State of New Mexico
Energy, Minerals and Natural Resources

OIL CONSERVATION DIVISION
1220 South St. Francis Dr.
Santa Fe, NM 87505

WELL API NO. 30-025-48764
5. Indicate Type of Lease STATE ☒ FEE ☐
6. State Oil & Gas Lease No.
7. Lease Name or Unit Agreement Name Prometheus State Com
8. Well Number 143H
9. OGRID Number 372043
10. Pool name or Wildcat TRIPLE X; BONE SPRING, WEST
11. Elevation (Show whether DR, RKB, RT, GR, etc.) 3556 GR

Tap Rock requests the following:

WELL LOCATION AND ACREAGE DEDICATION PLAT

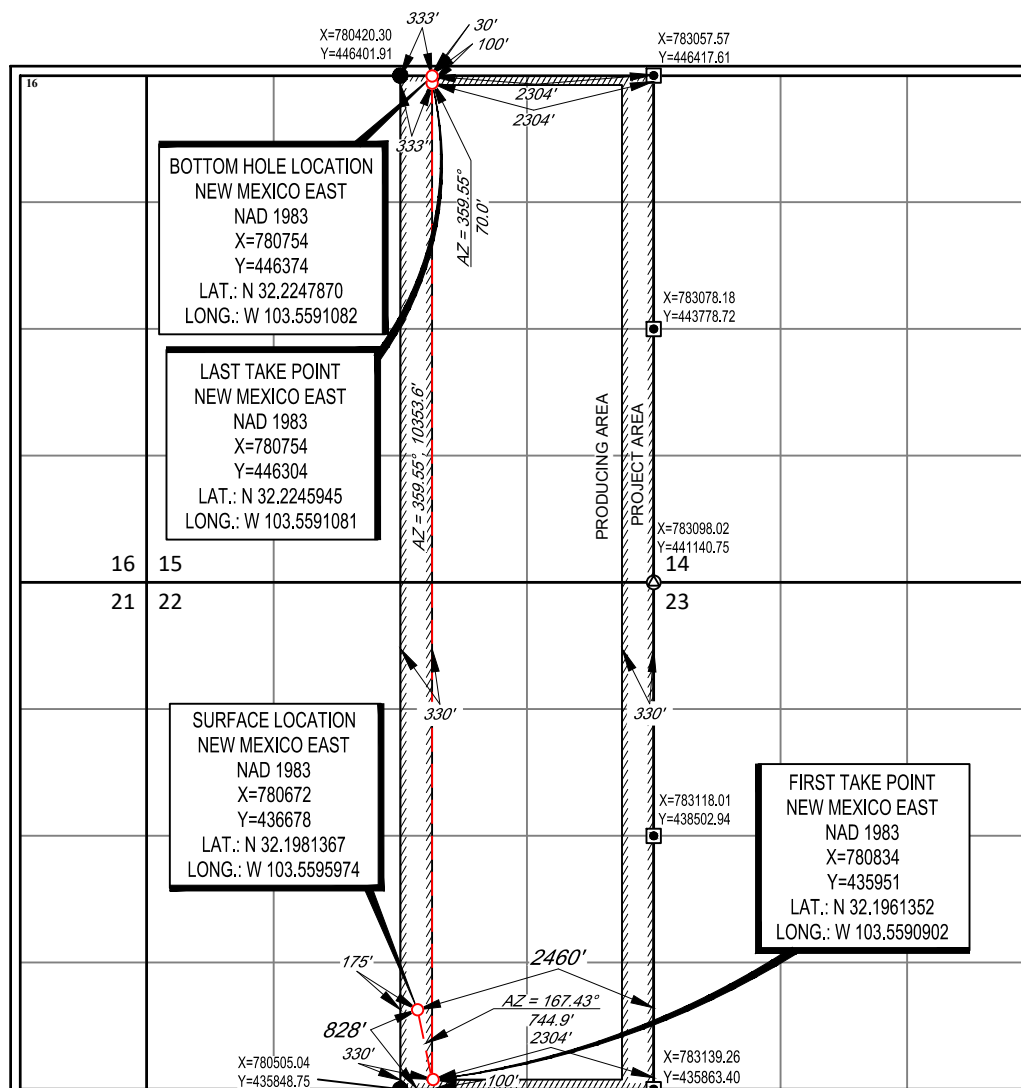
1. Change the spacing unit size to 640 acres compromised of Units A B G H I J O P 15-24S-33E and A B G H I J O P 22-24S-33E based on Prometheus State Com 144H (API 30-025-48765) as the defining well.
2. Change the OH size according to attached description of work and casing table.

¹² Dedicated Acres 640	¹³ Joint or Infill	¹⁴ Consolidation Code	¹⁵ Order No.
--------------------------------------	-------------------------------	----------------------------------	-------------------------
